AGENDA COVER MEMO

DATE: May 19, 2004

TO: Lane County Board of Commissioners

AGENDA ITEM TITLE: **IN THE MATTER OF APPROVING THE ALIGNMENT, RIGHT-OF-WAY WIDTHS AND OTHER DESIGN FEATURES FOR THE MARTIN LUTHER KING JR. PARKWAY, PREVIOUSLY KNOWN AS THE PIONEER PARKWAY EXTENSION, AS ADOPTED AND RECOMMENDED BY THE CITY OF SPRINGFIELD.**

Pedestrian Roadway Distance & Signalized Intersections

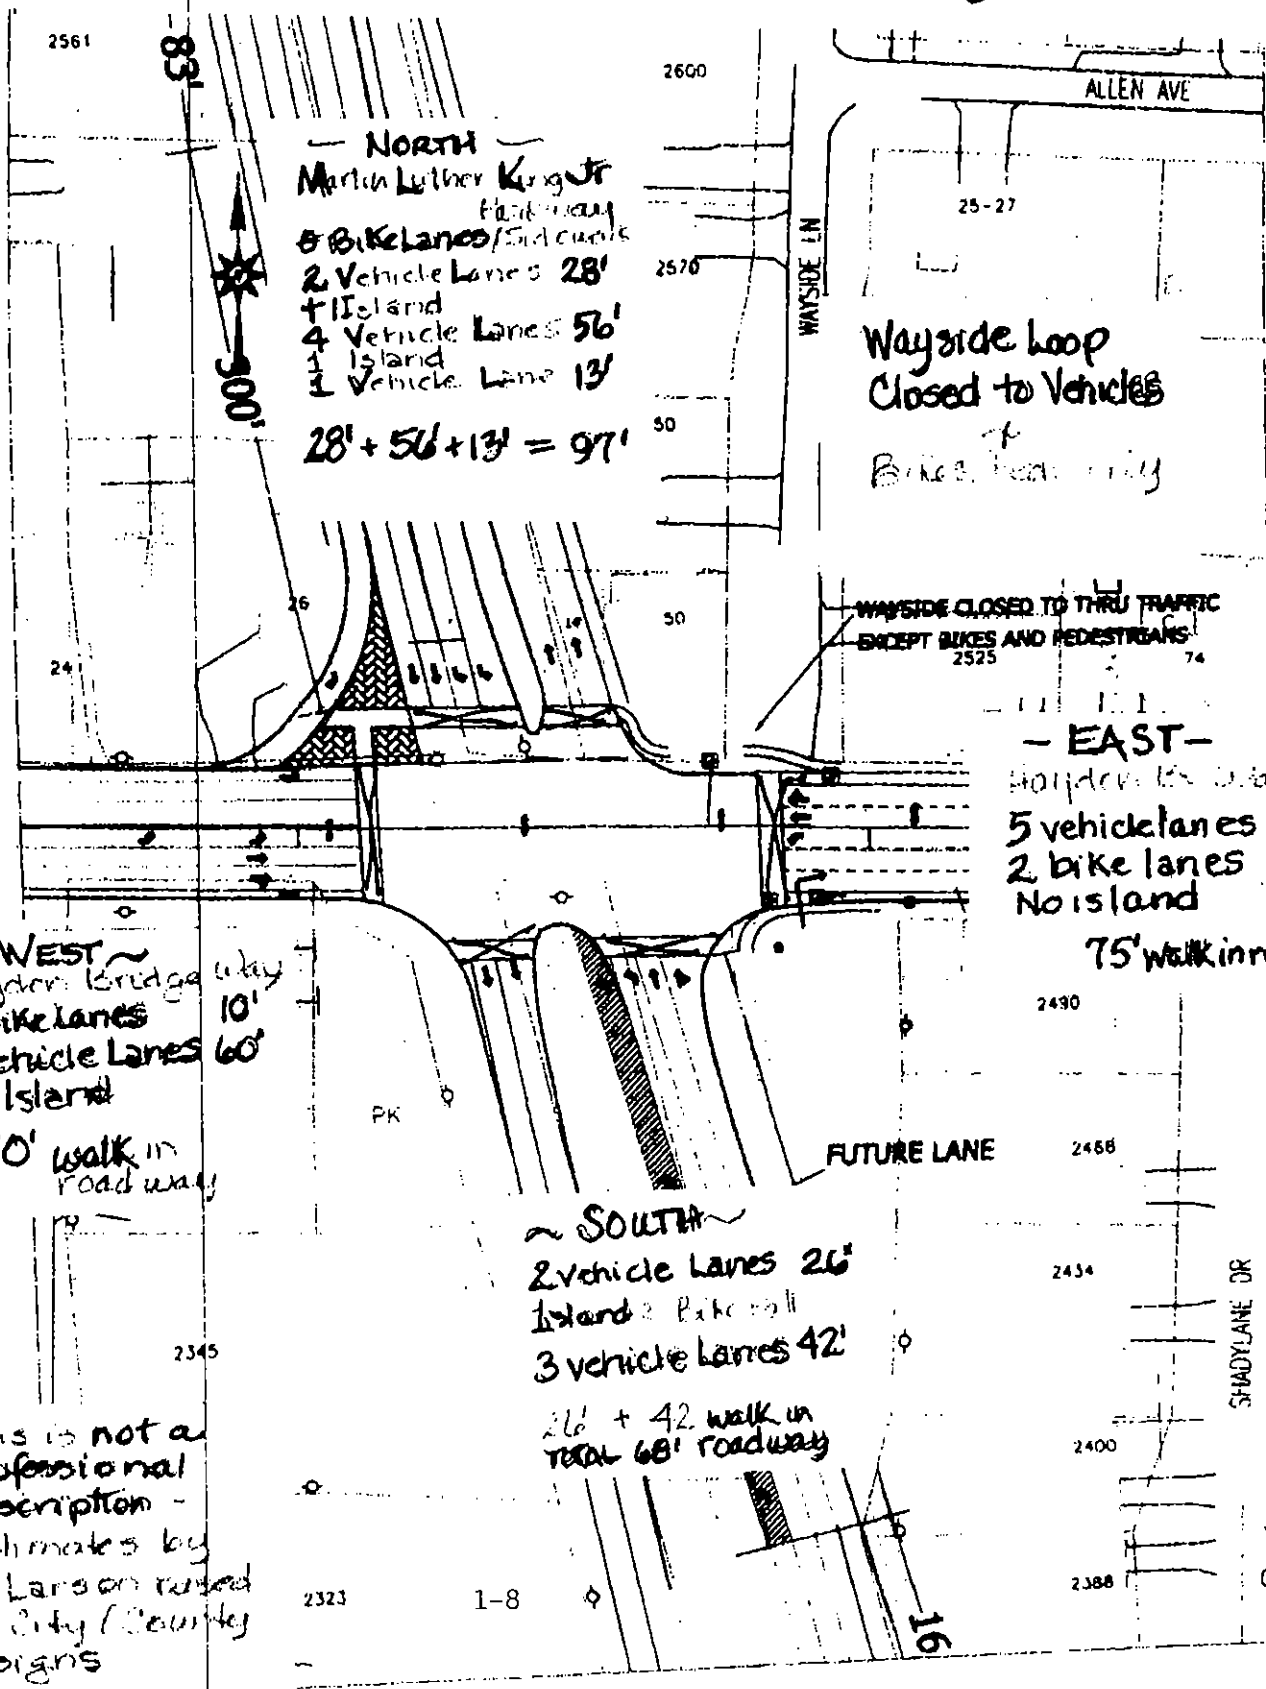
Maximum: 70-75' on HB West + west leg

Total In-Road Pedestrian Walkways: 310'

This is not a professional description - Estimates by C. Larson raised in City/County designs

Pedestrian In-Road Walk Distance with 5 Islands Traffic Circle Design

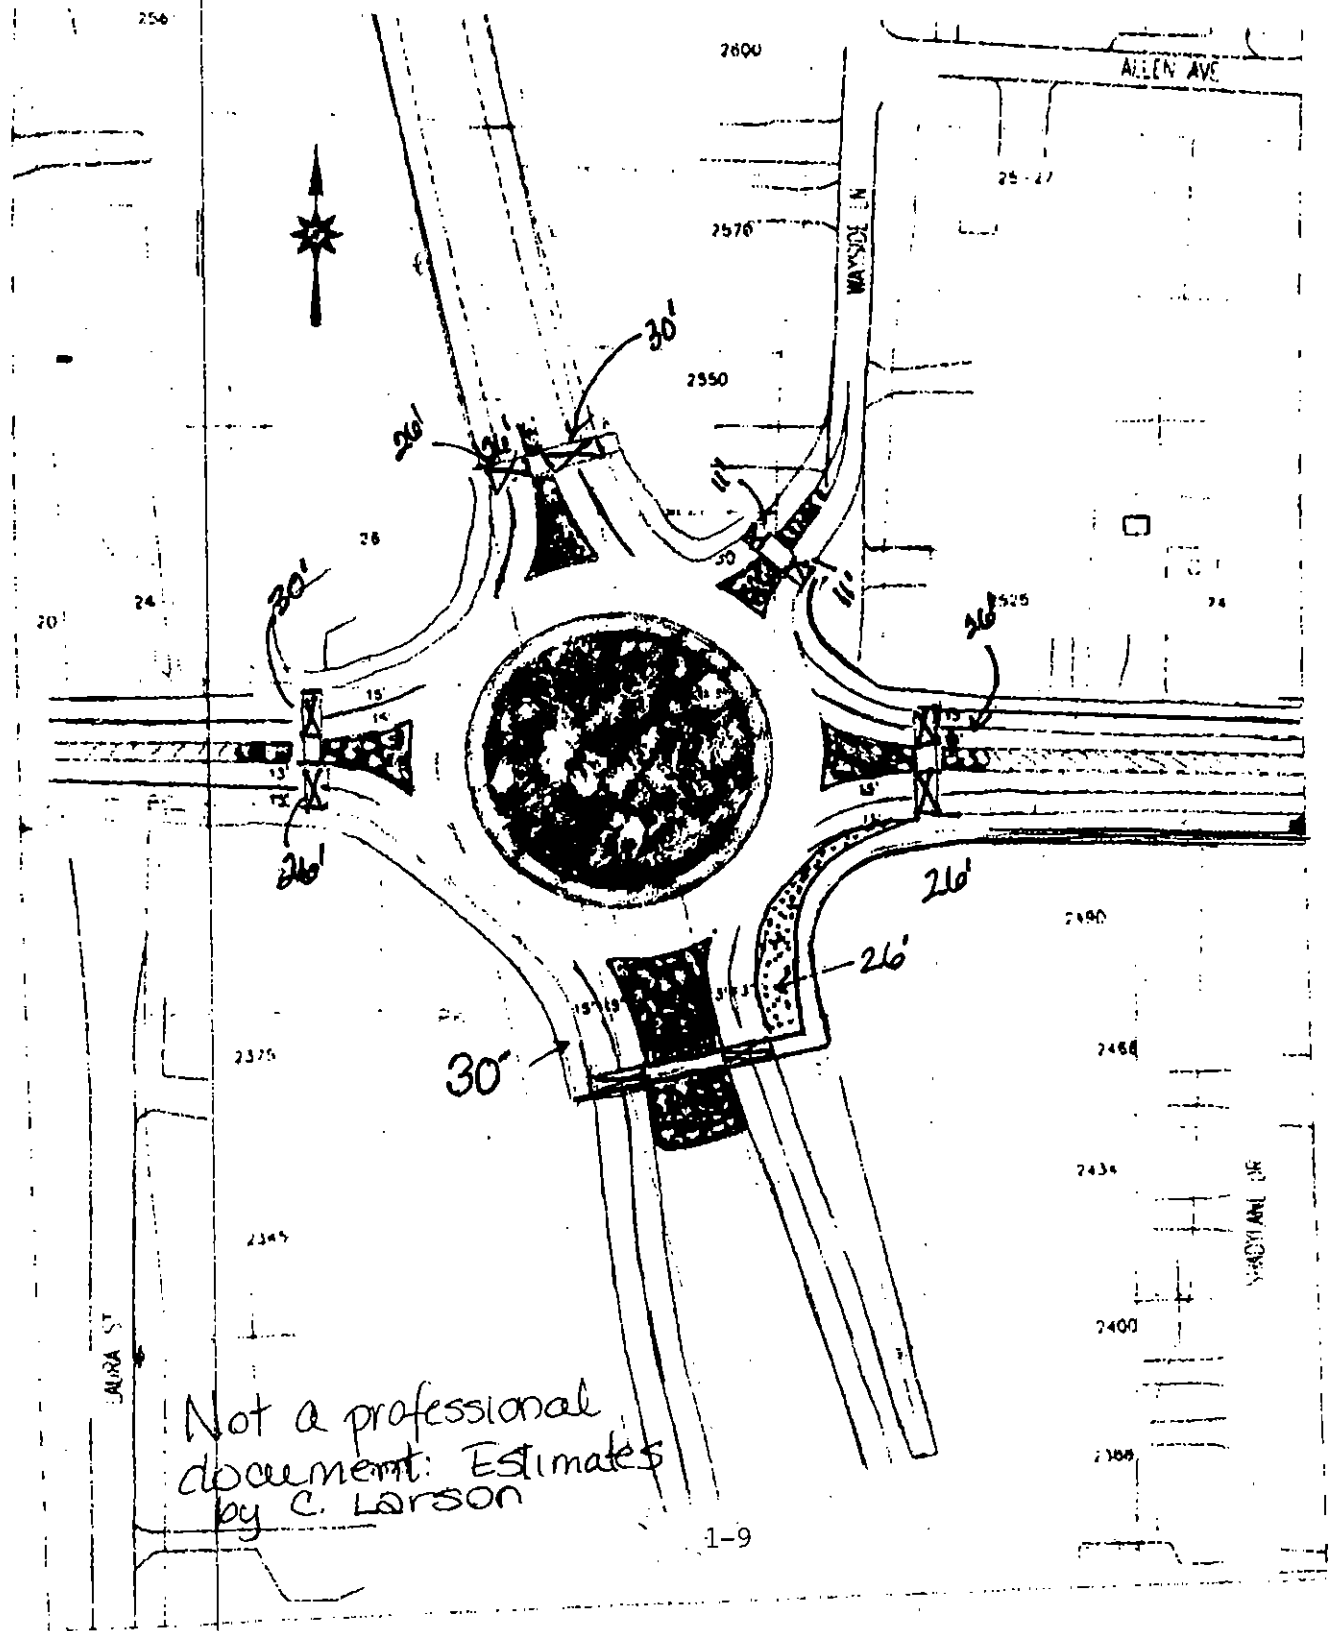
Maximum In-Roadway: 30'
Total: 240'
